Gatwick Airport Northern Runway Project

The Applicant's Response to Actions from Issue Specific Hearing 4: Surface Transport

Application Document Ref: 10.9.5

Title: **Surface Access Highways Plans Active Travel APFP Regulations 5(2)(o) Sheet 1**

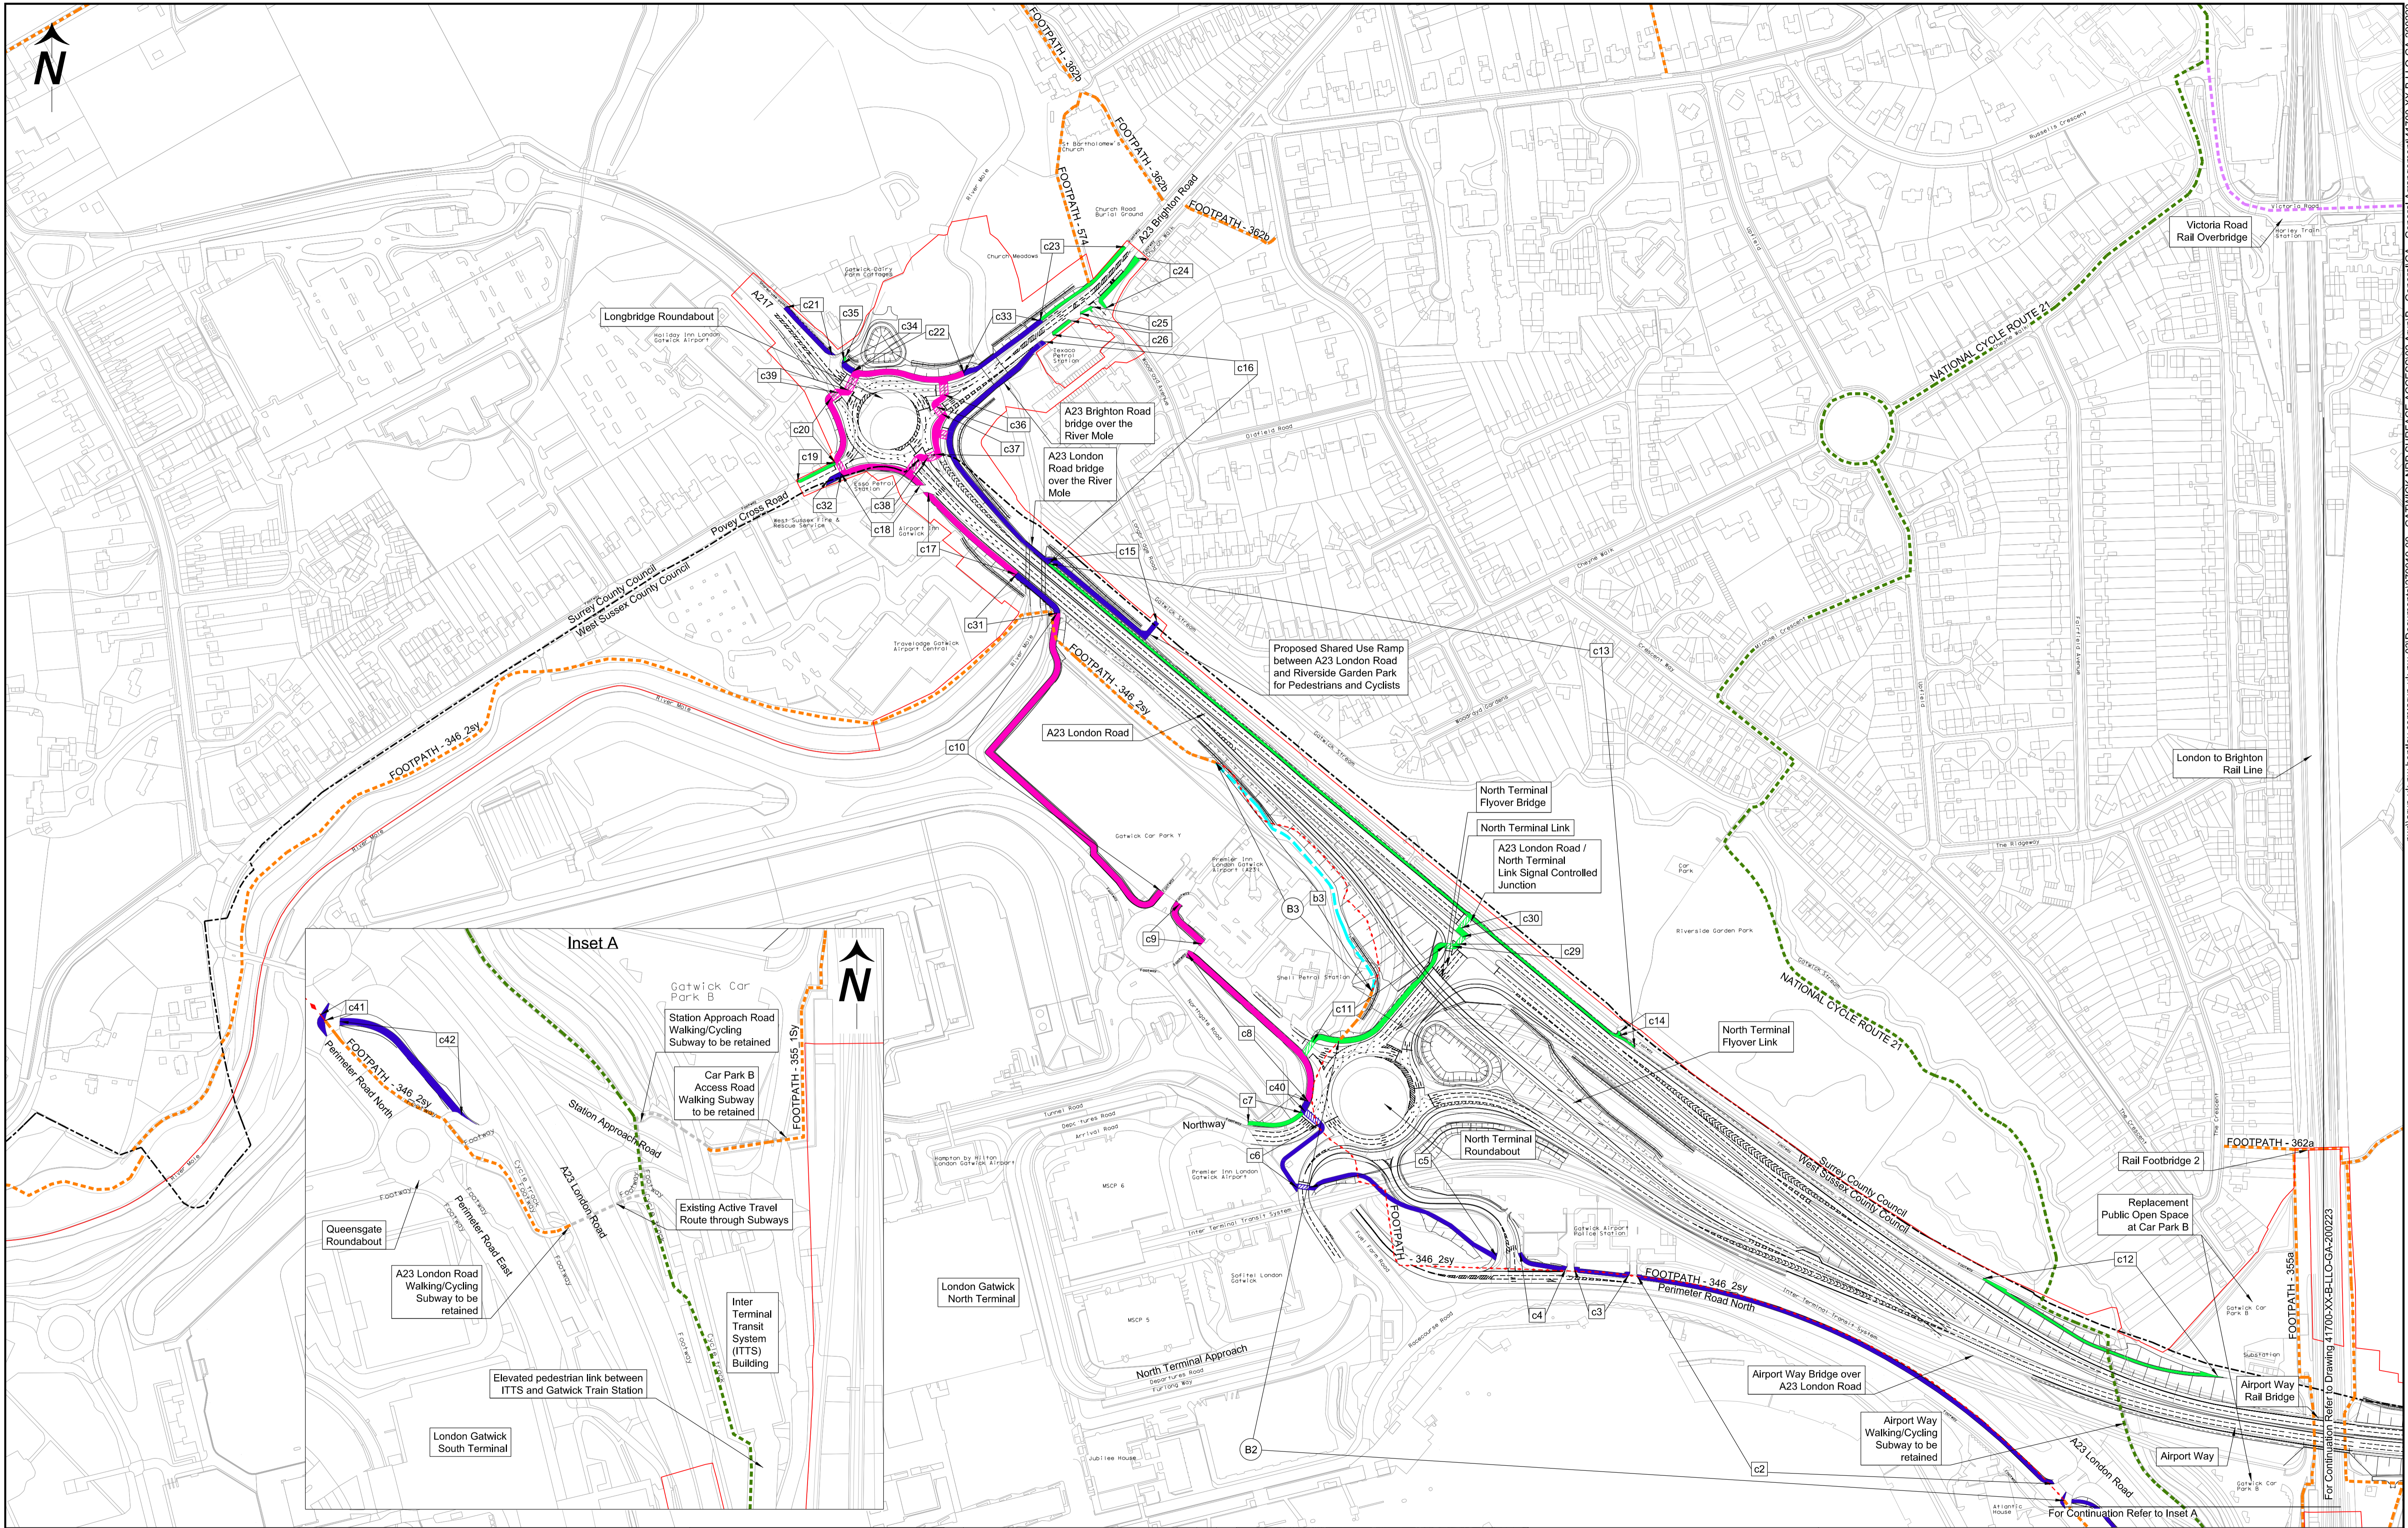
- 5.1.1 The ExA has requested that the Applicant submit a clearer movement framework to indicate pedestrian, cycle and shared routes indicating locations like cycle parking and entrances. This should also include an indication of widths of the various pedestrian, cycle and shared routes.

- **Longbridge Roundabout to North Terminal Roundabout to South Terminal/Gatwick Train Station & National Cycle Route (NCR) 21** (which provides onward connectivity to/from locations including Horley and Crawley) – Refer to provisions labelled c17, c31, c10, c9, c8, c40, c6, c5, c4, c3, c2, c41, c42 on Sheet 1 of the Active Travel plans in Appendix A with onward connectivity provided via existing routes illustrated in Sheet 1 Inset A;

- **Longbridge Roundabout to Riverside Garden Park** (which provides onward connectivity to southern Horley and NCR 21 via existing routes within the park) - Refer to label c15 on Sheet 1 of the Active Travel plans in Appendix A for the location of the proposed new ramp connection for pedestrians and cyclists between A23 London Road and Riverside Garden Park. Refer to provisions labelled c13 and c14 on Sheet 1 of the Active Travel plans in Appendix A for the extents of proposed footway widening on the eastern side of A23 London Road which provides improved connectivity to/from existing active travel connections into Riverside Garden Park and the new crossing of A23 London Road;

- **Southern Horley and North Terminal Roundabout** – Refer to provisions labelled c30, c29 and c11 on Sheet 1 of the Active Travel plans in **Appendix A**;
